To: T10 Technical Committee
From: Tim Symons, PMC-Sierra (Tim_Symons@pmc-sierra.com)
Date: 9 January 2007
Subject: 07-028r1 SAS-2 Address resolved zoning

This is a proposal to remove the address resolved references from the SAS2 draft.

Figure 56 — Example of a ZPSDS with the ZONE ADDRESS RESOLVED bit set to zero

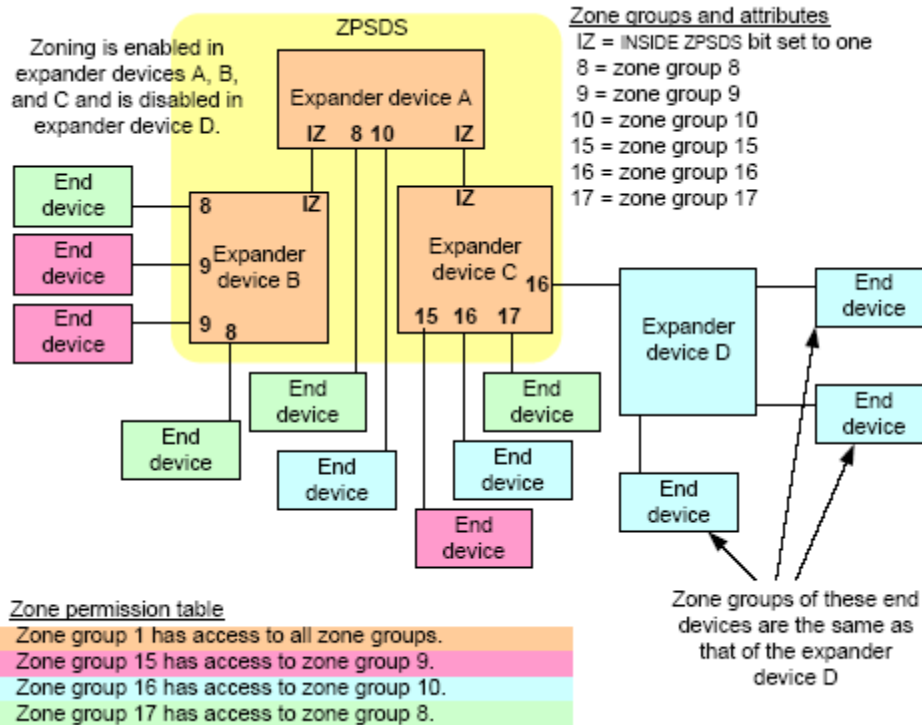
Figure 56 shows an example of a ZPSDS in which the ZONE ADDRESS RESOLVED bit of the expander port of expander device C that is attached to expander device D is set to zero.

Figure 57 shows an example of a ZPSDS in which the ZONE ADDRESS RESOLVED bit of the expander port of expander device C that is attached to expander device D is set to one.

Editors Note: DELETE FIGURE 57
